RE: Overman-Harvey Drain, Village Farms Sec. 16 Arm

Re: Overman-Harvey Drain: Village Farms Sec. 16 Arm

**VILLAGE FARMS  
UTILITY PLAN  
SECTIONS A & D**

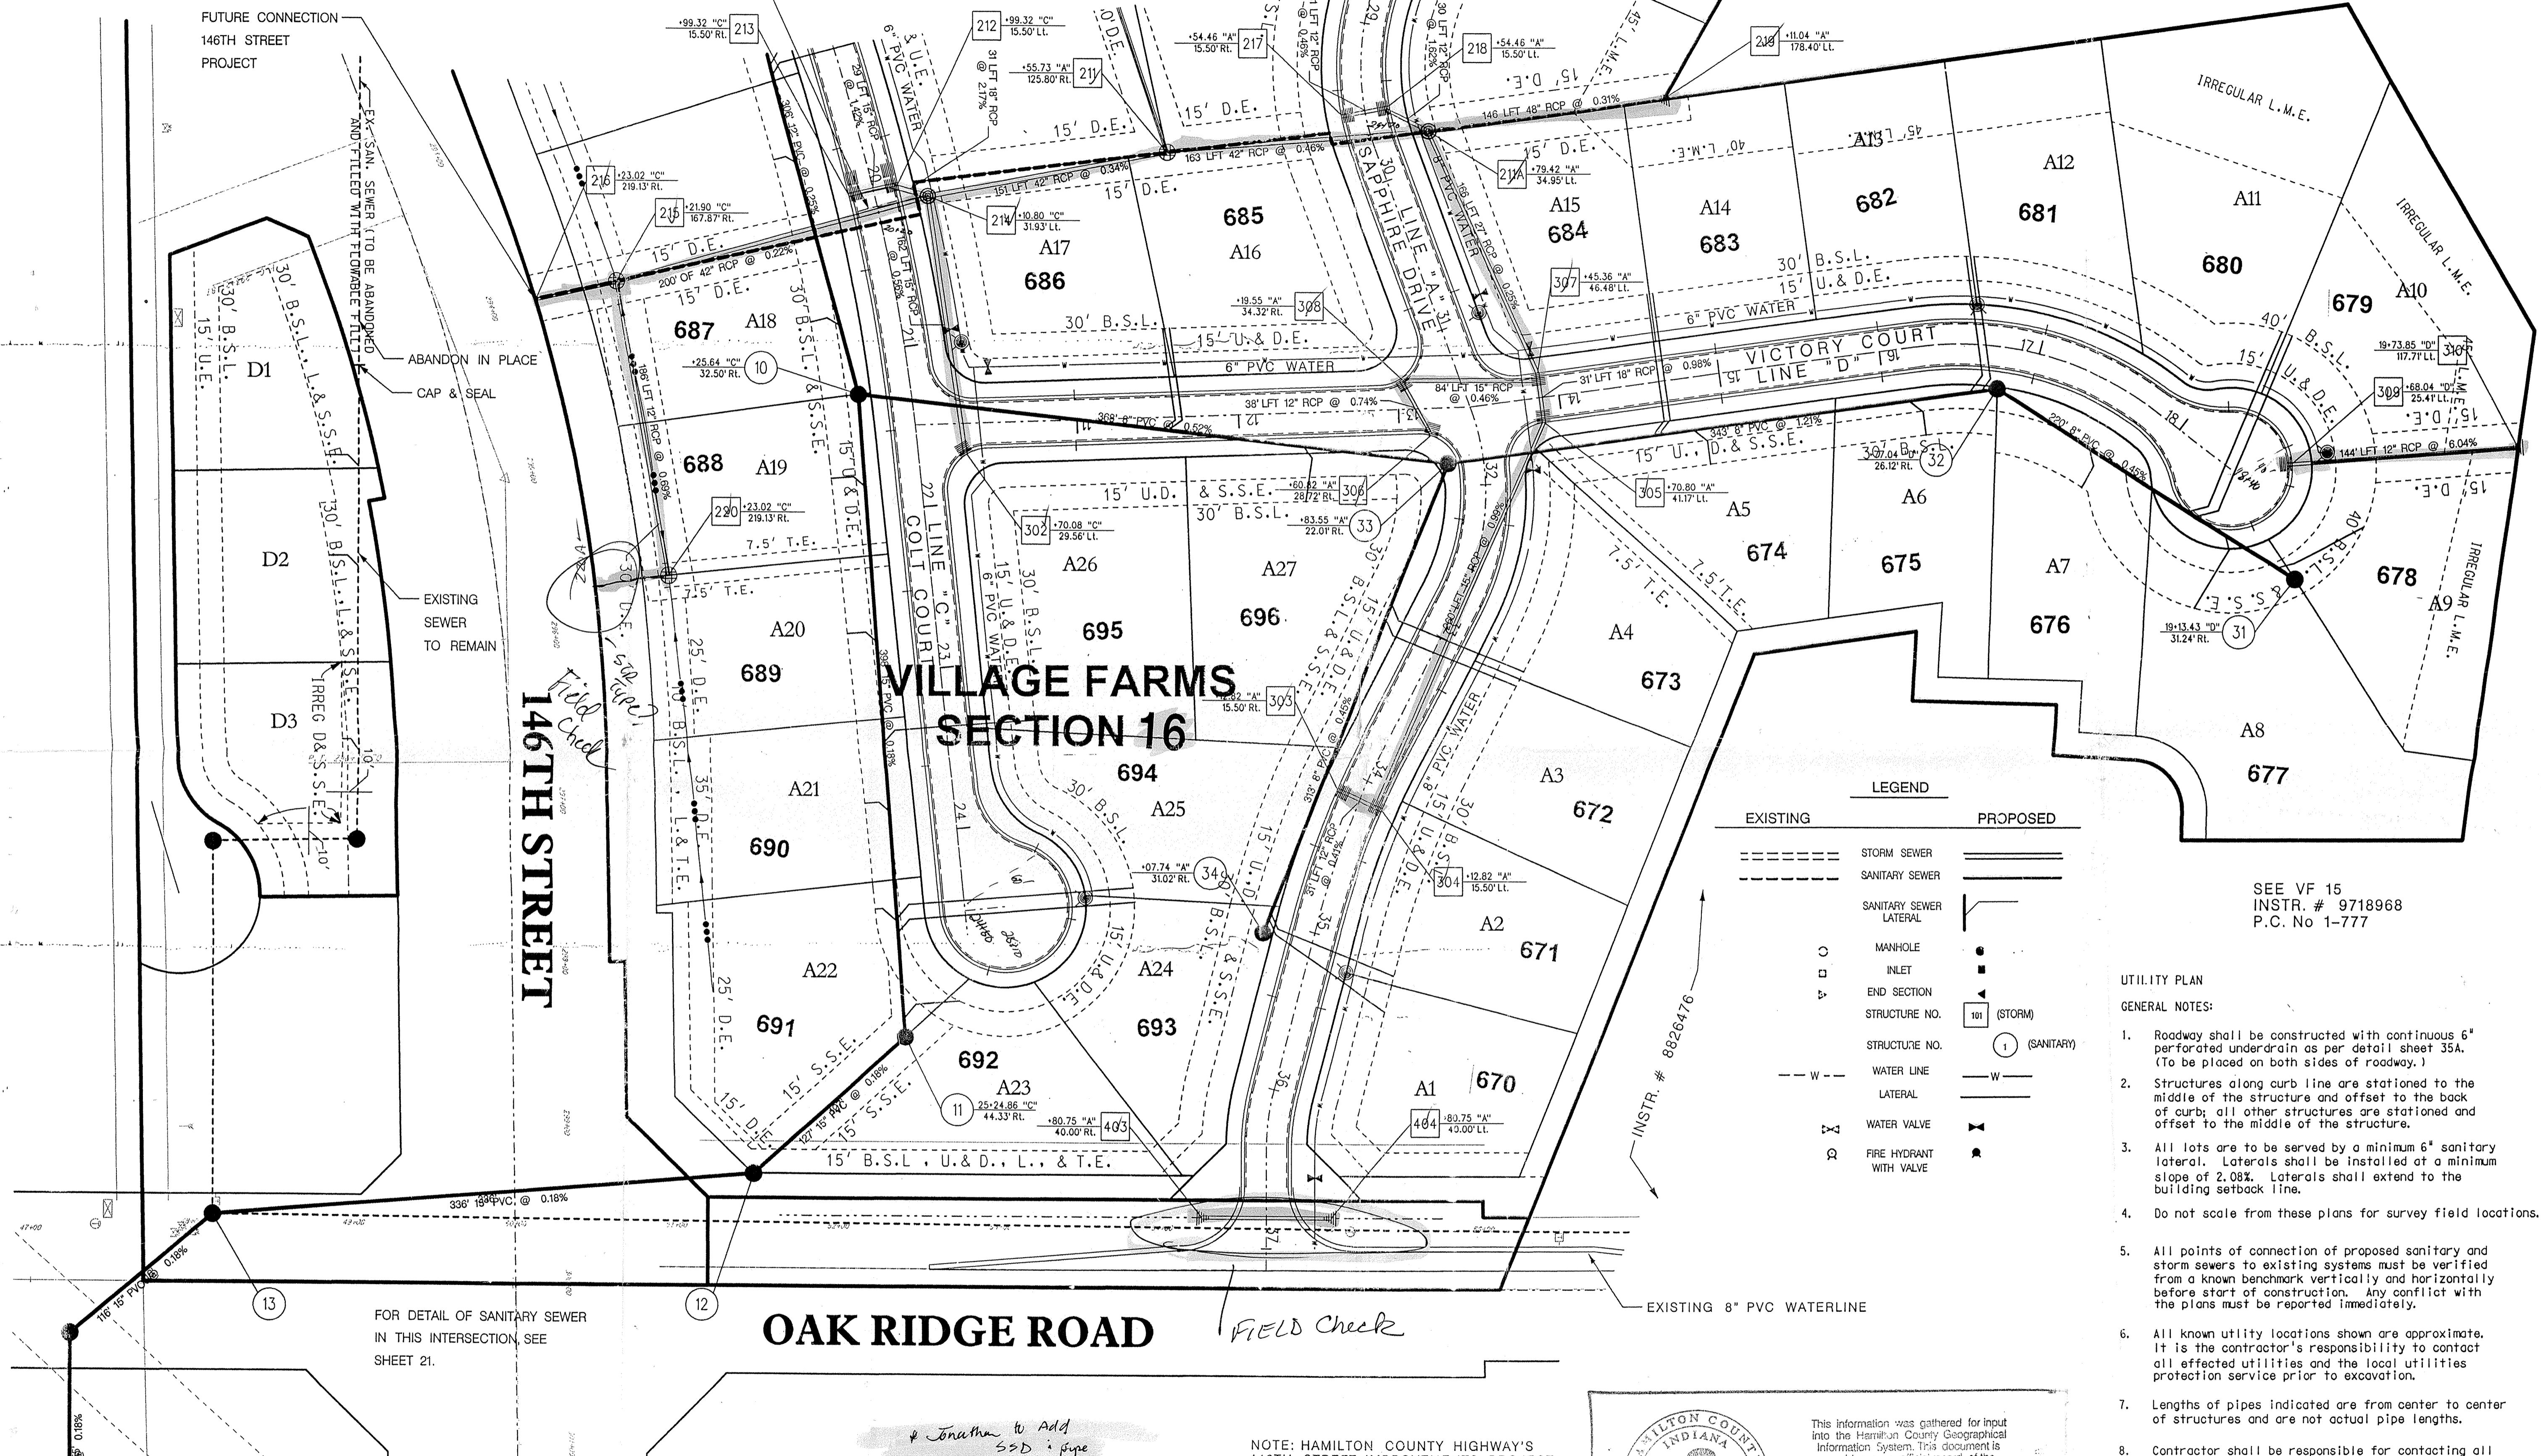
TAKE SSD ACROSS STREET AT 42" PIPE CROSSING. SSD MATERIAL WHEN CROSSING STREET TO BE SMOOTH-LINED AND NON-PERFORATED.

NOTE: HAMILTON COUNTY HIGHWAY'S 146TH STREET IMPROVEMENTS PROJECT TO INCORPORATE FUTURE DRAINAGE IMPROVEMENTS ALONG 146TH AND OAK RIDGE ROAD.  
*\* Jonathan to Add  
SSD pipe  
#0 Need SSD FOR 1718*
